Ref 40068_CroskellPSP

11 October 2024

**Croskell (Employment) PSP – Amendment C296case
Public Exhibition Response
1450 Thompson Road, Cranbourne East**

Figure 2 - PSP North-West Area - Extent of Cut (red) and Fill (blue) – Exhibited Solution

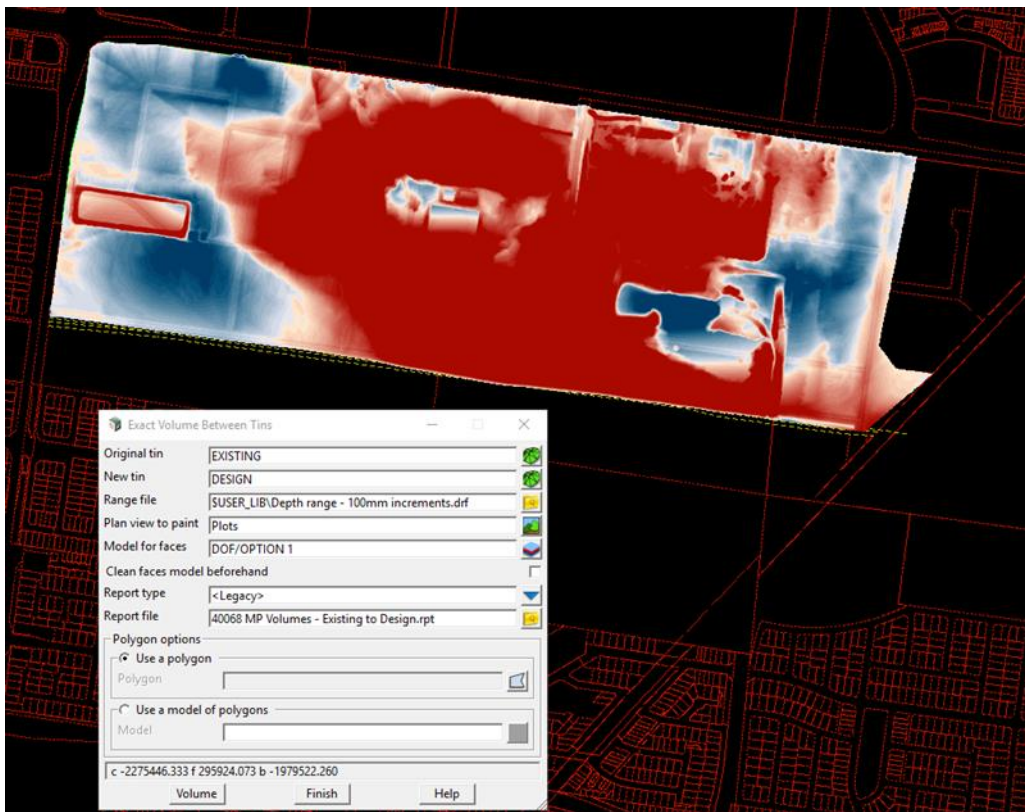
20.1. **Exhibited Solution** – as outlined in Appendix A, the exhibited solution presents significant constructability issues that result in the delivery of this drainage solution impacting the feasibility of the PSP. The main issues identified are listed below:

- The overland flow path pushes the road up to 5m in depth against the VDP cable easement.
 - This is not acceptable to DEECA/Aquasure and could not be delivered without prime PSP industrial land wasted to facilitate an appropriate sloped batter.

- If we were to replace the south interface batter with a retaining wall, this would be over 1.1km in length, and be at an exorbitant cost.
- Earthworks – to facilitate the levels of the southern industrial access road for the overland flow path, we have completed a conceptual design of the entire north-west PSP area. See Figure below, we have designed the internal east-west collector road and additional connecting roads north into Thompsons Road to match into existing road levels. To facilitate the levels required for a minimum graded rate (as flat as possible) along the south boundary, the works required are in the region of **2.5 million** cubic metres of earthworks moved on site. This excludes the earthworks required for the flat industrial pads expected in an employment area, which could easily exaggerate the volumes further.

- Filling of Moremac land – this drainage solution would require filling of the Moremac land by up to 5m in the south-west corner to ensure their site grades to the east.

- Additional Pipes for Overland Flow – the 22m width industrial access road will not be able to cater for the full gap flow. As such, an additional pipe would be required alongside the Pipe E 2x DN1650 pipes anyway to mitigate the public safety risks of excessive gap flow in the road.

Figure 3 - PSP North-West Area - Extent of Cut (red) and Fill (blue) – Proposed Solution

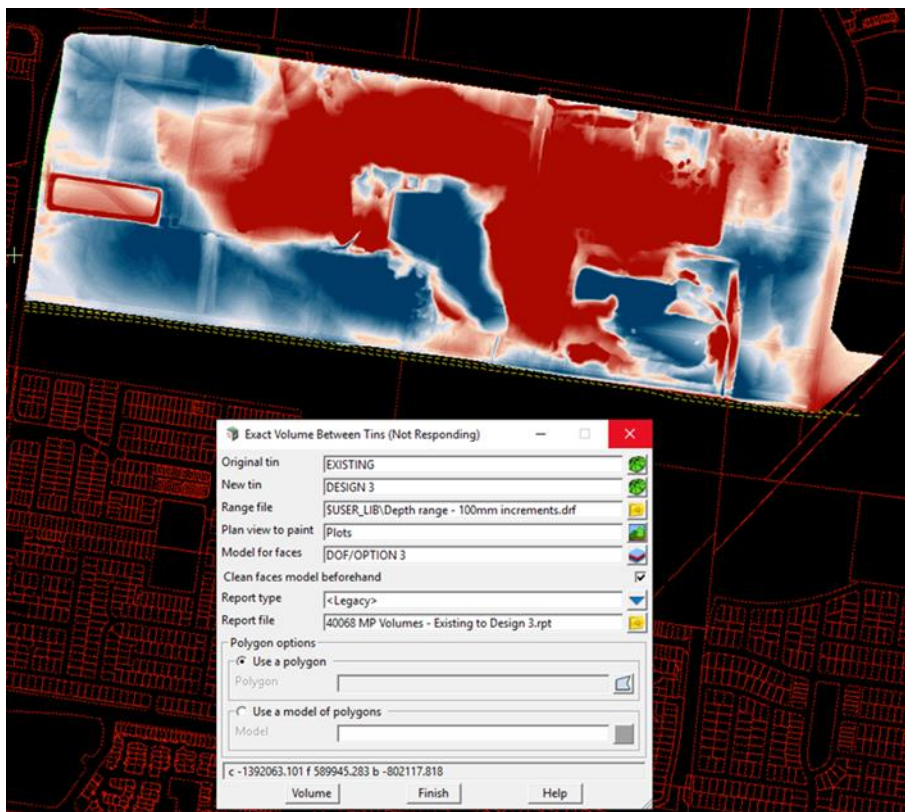
20.2. **Proposed Solution** – as outlined in Appendix A, the Proposed solution simply upgrades the Pipe E to a pipe that can cater for the full 1% AEP flow. This option results in the below benefits to the drainage strategy and overall PSP:

- 1% Pipe – we only add one (1) additional pipe to the Exhibited Solution, so at the outfall to the WLRB2 in MAB land, there are triple (3x) DN1650 pipes.

- The industrial access road against the VDP cable easement follows the existing contours and would only be ~2.0m in fill at its worst location.
- The Local Park LP-02 could be retained in its current location as shown in the PSP.

- Earthworks – designing the roads close to existing levels to minimise unnecessary earthworks, we have completed a conceptual design of the entire north-west PSP area. See Figure below, to facilitate the levels required for minimum graded roads (as flat as possible), the works required are in the region of **1.9 million** cubic metres of earthworks moved on site. This excludes the earthworks required for the flat industrial pads expected in an employment area, which could easily exaggerate the volumes further.

- Filling of Moremac land – minimal filling on the Moremac land.
- The pre-developed flow is now shifted into the 1% pipe, so the 4.05 m³/s of flow going over the VDP cable in the existing scenario can be effectively used as buffer against storm events in excess of the 1% AEP flood.

- Swale F can be reclaimed as prime industrial developable land, as the pipe interfaces directly with the proposed WLB2.

Figure 4 - VicRoads Standard Detail SD1621 - Pavement under Kerb

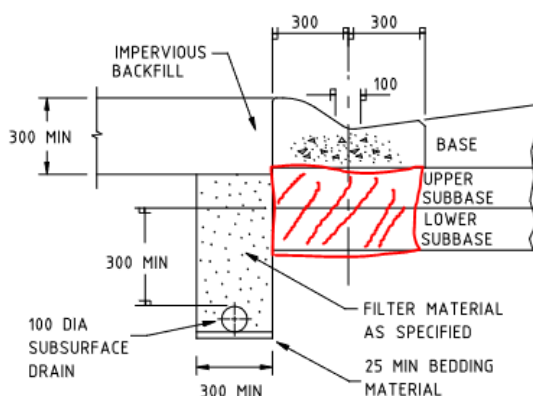
- Pavement areas - appear to have only been measured as trafficable area – they do not account for the additional 600mm width of subbase pavement under kerb. See Figure below, being a sketch of VicRoads Standard Detail SD 1621 – the red hatching is the additional pavement under the kerb. This results in additional pavement area of ~ 270 sq.m.

Figure 6 - Typical Pavement Connection Detail for interface with ex. pavement

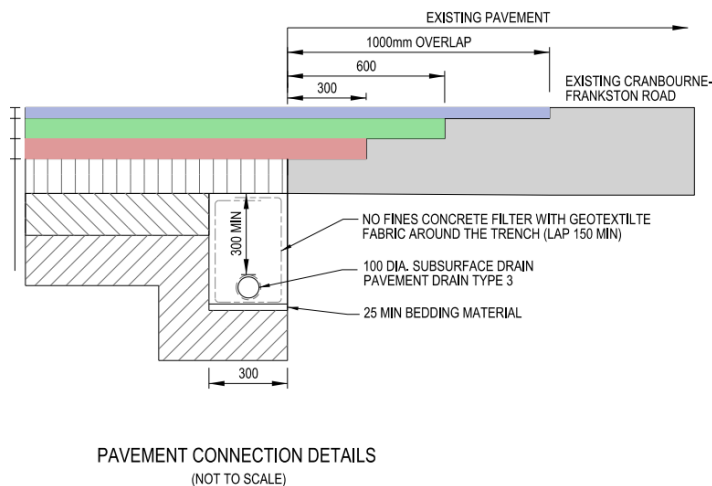
- 25.2. Pavement rates - are in the ballpark, however we have slightly increased them.
- 25.3. NEW ITEM 2.3.1 - Subgrade improvement. Site conditions in this area will likely require lime/CT stabilisation which would be ~\$55/sq.m for the pavement area = \$170,000
- 25.4. NEW ITEM 2.3.2 - Interface Pavement works. DPT/VicRoads won't permit pavement works to be completed against the hard edge of existing pavement once the ex. kerb is removed. We will need to interface each pavement layer as per VicRoads requirements, see Figure below which shows how this would typically be implemented.

Figure 7 - Croskell ICP IN-04 Intersection - SMEC FLP - Additional Asphalt overlay

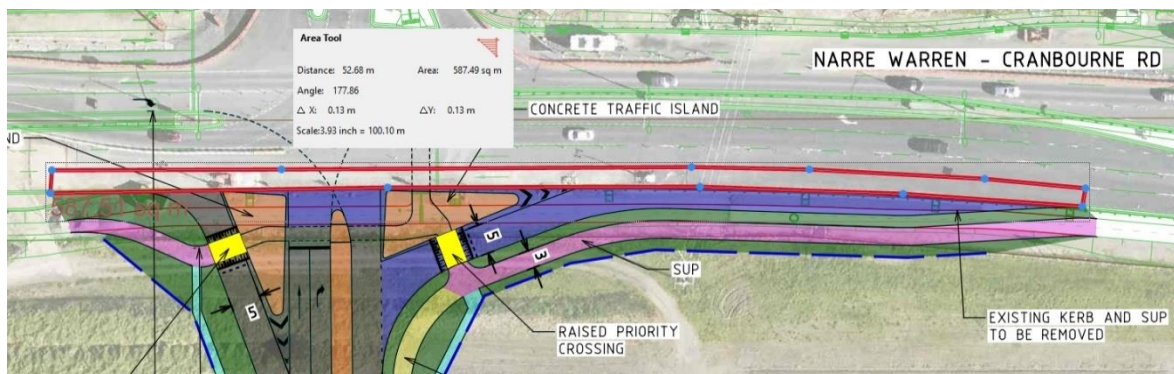
- 25.5. NEW ITEM 2.3.3 - Asphalt Overlay on Ex. Road. DPT/VicRoads will require a wearing course asphalt overlay of the existing intersection of at least the entire adjacent lane (3.5m width). This area of 587sq.m has been added to the schedule.

Figure 10 - Croskell ICP IN-04 Intersection - SMEC FLP - southern splay

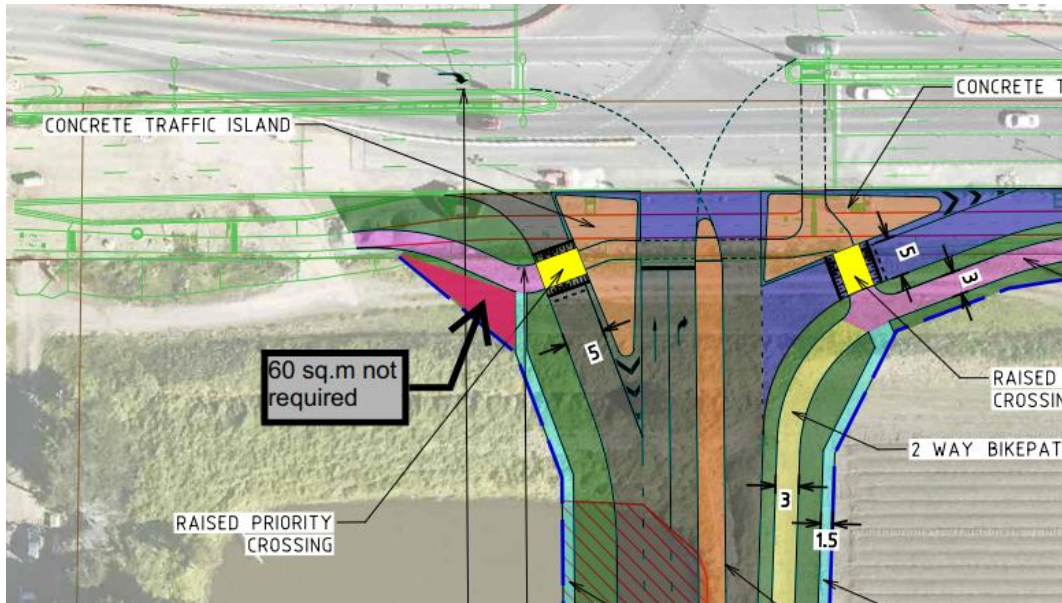
26. **IN-04 Land Take** – is it noted in Table 8 that as per the SMEC FLP of IN-04, there is a land-take of 0.58ha required.

Marshal and our traffic engineer expert Traffix Group have assessed the FLP provided by SMEC. We note that the south left-hand turn lane from the Collector Road into Narre-Warren-Cranbourne Road has assumed a large conservative splay that is not close to the back of footpath. See below Figure, in red hatching we note that at least 60 sq.m of this splay could be reclaimed by the adjacent lot, as there does not appear to be a sight-distance, Austroads or geometric design reason for this large splay.

We request that the VPA revise the land take requirement of ICP IN-04 to be reduced by 60 sq.m.

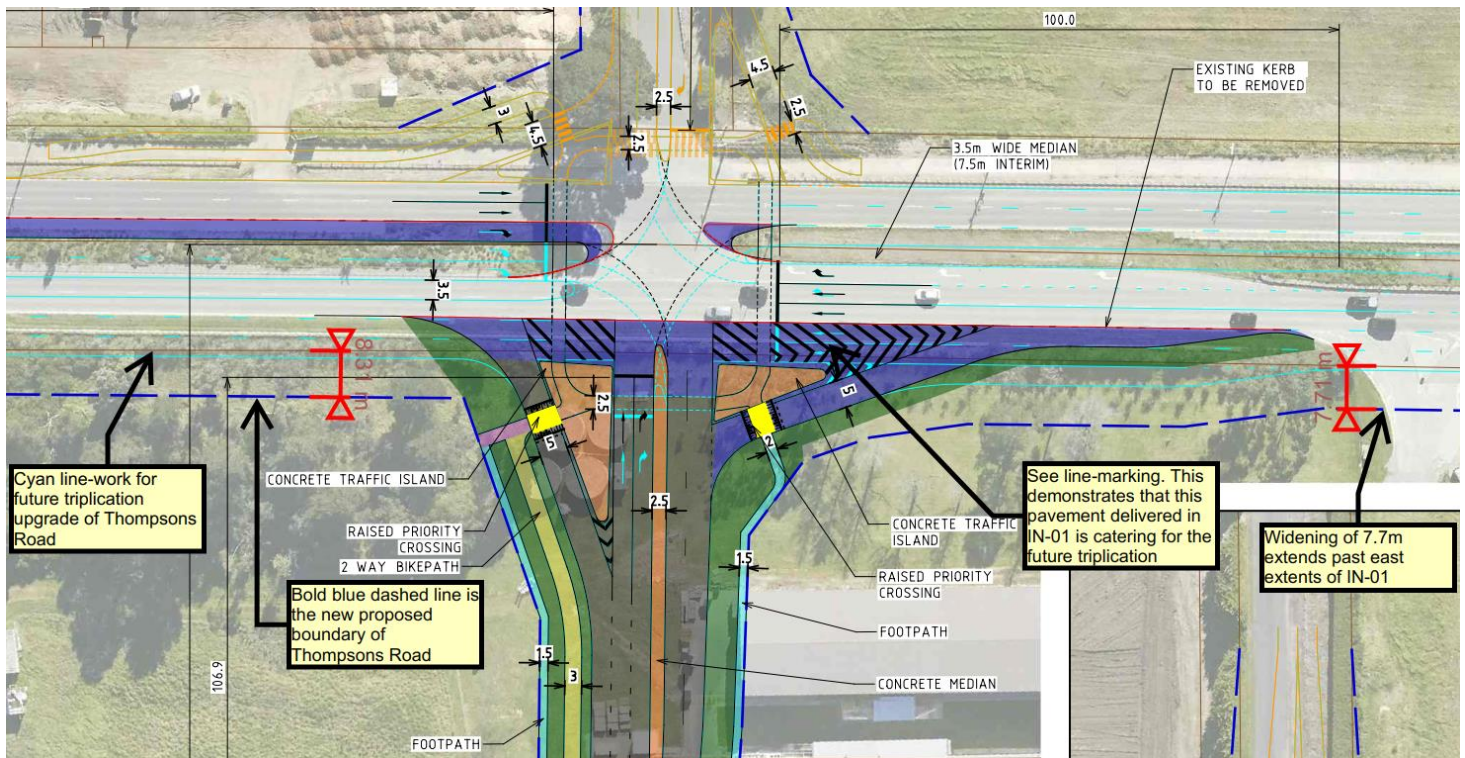
27. **IN-01, IN-02 & IN-03 Thompsons Road Widening**– SMEC has provided FLP design of both IN-01, IN-02 and IN-03; all intersections on Thompsons Road on the north boundary of the PSP.

As raised in our VPA meeting of 4 October 2024, we note that there is up to a 8.3m road widening of Thompsons Road into private property as shown on the SMEC FLP plans of IN-01, 5.5m of widening adjacent to IN-02, and 5.0m of widening adjacent to IN-03. See the Figure below for this dimensioning on IN-01, with the new title boundary of Thompsons Road shown in a thick bold dashed blue.

It is evident to us that the FLP design of these intersections has been made to consider the future triplication of the Thompsons Road, which requires a consistent widening south of the Thompsons Road boundary. This is confirmed by the below factors:

1. The road widening (shown in dashed blue) appears to extend past the extents of the land widening provided in the ICP for the intersections and continues east and west past the limit of the intersections.

2. Cyan line-work is the future triplication of Thompsons Road, some of this linework is shown in current private property.
3. There is 'dead' pavement provided with 'no-go' dashed line-marking that clearly aligns with the future third lane of west-bound Thompsons Road.

4. IN-02 and IN-03 – the west relocated bus stop is located significantly further south than the current carriageway edge. It appears to be designed to cater for the cyan-coloured linework of the future triplication.

5. Footpaths are located within current private property at a consistent offset to the cyan triplication linework.
6. Plan 2 – Place Based Plan of the PSP shows a dark-grey hatching on the underside of Thompsons Road for the entire north boundary of the PSP, which is consistent with what is shown on the SMEC FLP plans. This dark-grey hatching appears to indicate required road widening.

This widening of Thompsons Road is not shown in the exhibited amendment documentation as Public Acquisition Overlay, nor as ICP land to be factored into the Land Equalisation table.

We note that the VPA has advised us that the further upgrade of Thompsons Road is not considered by the Croskell PSP however it is concerning that a clear widening is shown by the SMEC plans, but not mentioned in any PSP or ICP documents.

We request the VPA re-confirm this with DTP and update the PSP and engineering plans accordingly.

Should the DTP revert and confirm an omission on their end; being that a consistent road widening is required along the south boundary of Thompsons Road; we request that the PSP and ICP is updated ensuring landowners are appropriately compensated for their loss of developable land to a public upgrade.
